# Access Compliance Report

## Public Rights-of-Way

### (Curb Ramps)

| Intersection ID: 47833 | Main Street: TOM_SHORT_RD | Cross Street: SPUR_RANCH_RD | Location: SE           |

| ADA ID: A3124606F553   | Ramp Type: BlendTrans1    | Initial Pass/Fail: Fail     | Overall Compliance: No |

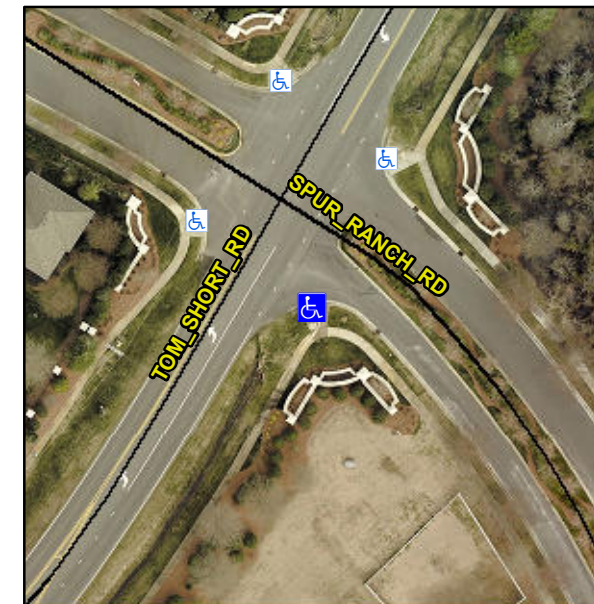
**Remove & Replace Curb Ramp With Two New Directional Ramps or Equivalent.**

**R304.5.1, R304.5.3**

| Compliance | Description           | Data  | Compliance | Description                 | Data  |
|------------|-----------------------|-------|------------|-----------------------------|-------|
| No         | Ramp Width (in)       | 46.0  | No         | BlendTrans XSlope (%)       | 5.4   |
